Access Compliance Report

Public Rights-of-Way

(Curb Ramps)

Intersection ID: 22001	Main Street: HIGHVIEW_RD	Cross Street: STOCKTIE_RD	Location: NE
ADA ID: B85745002A64	Ramp Type: BlendTrans1	Initial Pass/Fail: Fail	Overall Compliance: No
Severity Score: 21.25			
Codes/Mitigation Info/Possible Solution		Field Measurements/Component Compliance

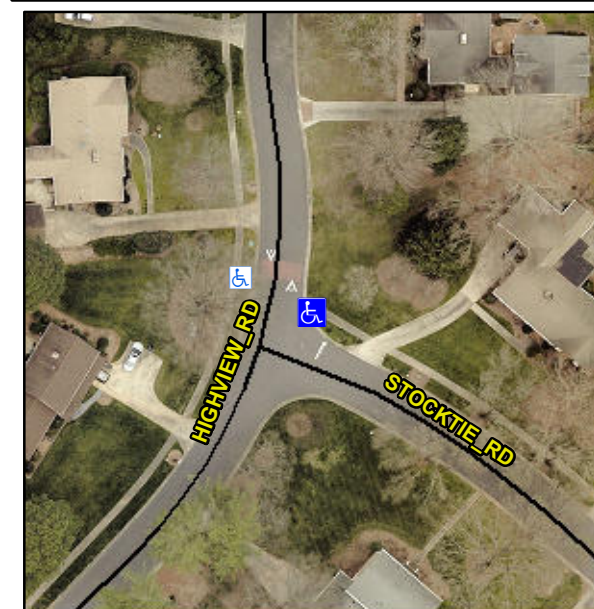
Not Found, R304.5.1, R304.5.3

Compliance	Description	Data	Compliance	Description	Data
N/A	Ramp Length (in)	101.0	Yes	BlendTrans Slope (%)	4.3
No	Ramp Width (in)	37.0	No	BlendTrans XSlope (%)	5.5
N/A	Flare Type LT	N/A	N/A	Flare Type RT	N/A
N/A	Flare Slope LT (%)	N/A	N/A	Flare Slope RT (%)	N/A
N/A	Flare Traversable LT?	N/A	N/A	Flare Traversable RT?	N/A
N/A	Landing Length (in)	N/A	N/A	DWS Provided?	N/A
N/A	Landing Width (in)	N/A	N/A	DWS Contrast?	N/A
N/A	Landing Slope (%)	N/A	N/A	DWS Length (in)	N/A
N/A	Landing X Slope (%)	N/A	N/A	DWS Full Width?	N/A
N/A	Landing Curb? (Y/N)	N/A	N/A	DWS Offset (in)	N/A
N/A	Shared Landing?	N/A			
N/A	Gutter Ponding?	N/A	N/A	Gutter Slope (%)	N/A
N/A	Gutter Lip Ht (in)	N/A	N/A	Gutter X Slope (%)	N/A
N/A	Painted X Walk1?	No	N/A	Painted X Walk2?	No
	X Walk 1 Direction	To NW		X Walk 2 Direction	To S
	X Walk 1 Width (in)	N/A		X Walk 2 Width (in)	N/A
	X Walk 1 Slope (%)	7.9		X Walk 2 Slope (%)	3.1
	X Walk 1 X Slope (%)	3.4		X Walk 2 X Slope (%)	4.7

N/A	Ramp inside XWalk1?	N/A	N/A	Ramp inside XWalk2?	N/A
	Road Slope (%)	4.2		Clear Space?	N/A
	Road X Slope (%)	8.8	N/A	Clear Space to XWalk (in)	N/A
N/A	Any Obstructions?	N/A	N/A	Storm Grate/Utility Hazard?	N/A
	Obstruction Type			Storm Grate/Utility Type	
		N/A			N/A
			Yes	Surface Condition? (G/P)	Good
			No	Curb Slope (%)	8.9

Remove & Replace Curb Ramp With Two New Directional Ramps or Equivalent.
